Westinghouse Non-Proprietary Class 3

RAI Responses for WCAP-17661-P/ WCAP-17661-NP, Revision 1

RAI Responses for WCAP-17661-P/ WCAP-17661-NP, Revision 1 (Non-Proprietary)

Figure RAI-6.1 Comparison of Predicted Trend in $F_Q^C(Z)$ or $F_Q^W(Z)$ as a Function of Cycle Burnup for an Example Plant

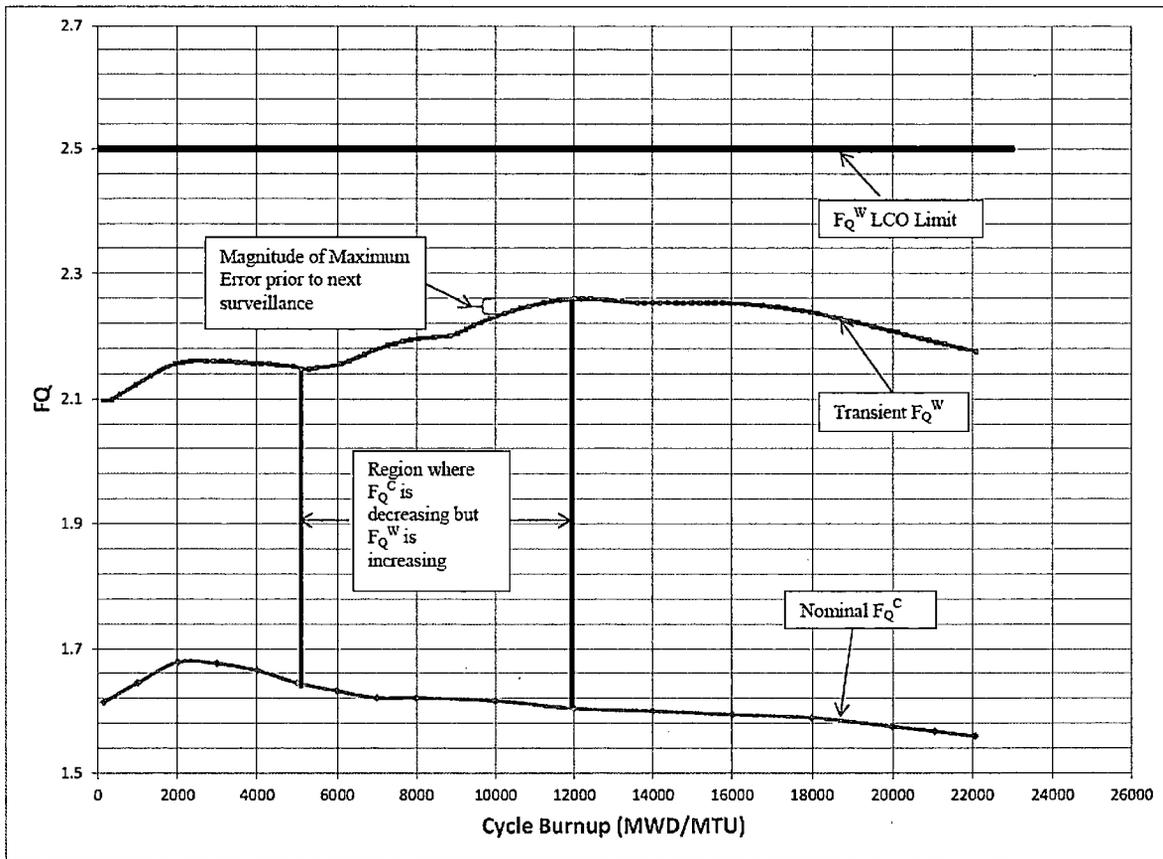
- a. Explain how this would actually take place.
- b. Provide data from past experience and additional discussion supporting the statement "past measurement trends of $F_Q^C(Z)/K(Z)$ may or may not be indicative of future margin trends."

An issue has been identified that the use of measured trends in $F_Q^C(Z)$ may not always be indicative of the same margin trend in the measured $F_Q^W(Z)$, particularly when the axial power distribution of the core is in transition from a cosine type shape to a flattened saddle type shape. Figure RAI-6.1 illustrates an example of such a case by comparing the predicted steady state and maximum transient F_Q values for an example cycle.

Furthermore, it must be clarified that the initial onset of CIPS will not necessarily result in observing a decreasing trend in either the $F_Q^C(Z)$ or $F_Q^W(Z)$ margin. The preferential accumulation of boron-containing crud in high power assemblies will tend to decrease the radial peaking ($F_{XY}(Z)$) in the affected elevations of the highest power assemblies. If the nominal predicted AFD is slightly positive, the onset of CIPS may result in the AFD being closer to zero or slightly negative. Both of these factors could result in an increasing trend in margin for $F_Q^C(Z)$, initially. The trend in $F_Q^W(Z)$ is driven largely by the $T(Z)$ or $W(Z)$ surveillance factors, which, as noted in Section 4.5 of WCAP-17661-P, will not include the effects of CIPS if it occurs. Thus, the observation of past trends in margin for either $F_Q^C(Z)$ or $F_Q^W(Z)$ is not very useful in identifying the onset of CIPS. Only in the later stages of a relatively severe CIPS event can it be stated with high confidence that the $F_Q^C(Z)$ margin will be decreasing with burnup.
